UNITED STATES
DEPARTMENT OF THE INTERIOR
BUREAU OF LAND MANAGEMENTFORM APPROVED
OMB NO. 1004-0137
Expires: January 31, 2018**SUNDRY NOTICES AND REPORTS ON WELLS**
*Do not use this form for proposals to drill or to re-enter an abandoned well. Use form 3160-3 (APD) for such proposals.*5. Lease Serial No.
NMNM86153

8. Well Name and No.
TOMCAT FED 21 019. API Well No.
30-025-33356-00-S110. Field and Pool or Exploratory Area
DIAMONDTAIL
TRISTE DRAW-DELAWARE11. County or Parish, State
LEA COUNTY, NM**SUBMIT IN TRIPLICATE - Other instructions on page 2**

**** BLM REVISED ** BLM REVISED ** BLM REVISED ** BLM REVISED ** BLM REVISED ****

PROPOSED WELLBORE

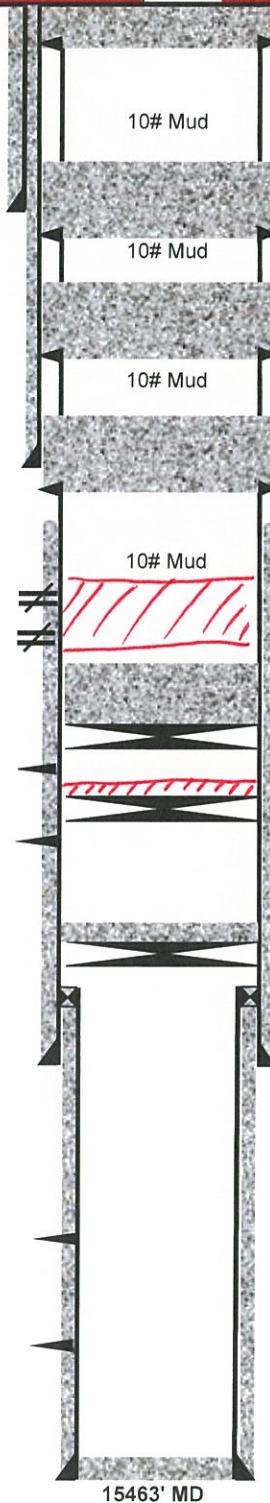
Proposed:
 1. Perf at **630' 630'**
 2. Sqz 35 sx CI C from 680'-580'. WOC & tag.
 (Shoe @ 630')

Proposed:
 1. Perf at **1585' 1600'**
 2. Sqz 35 sx CI C from **1585'-1480'**. WOC & tag. **1600'-1480'**
 (T. Salt @ **1533'** **1550'**)

Proposed:
 1. Perf at **4810' 4892'**
 2. Sqz **85** sx CI C from **4810'-4550'**. WOC & tag **4892'-4550'**
 (Top Delaware @ **4760'**; Shoe @ 4720'; B. Salt @ **4600'** **4720'** **105** sx)

Proposed:
 1. Set CIBP @ 8370'. Tag. Circ 10# salt gel. **Leak Test CIBP**
 2. Spot 115 sx CI H from 8370'-7800'.
 (Open perms at @ 8418')

CIBP set @ 8560' (7/9/2012) **spot 25 sx CI H TAG**
→ Bone Spring Top @ 8628' 8560'-8510'
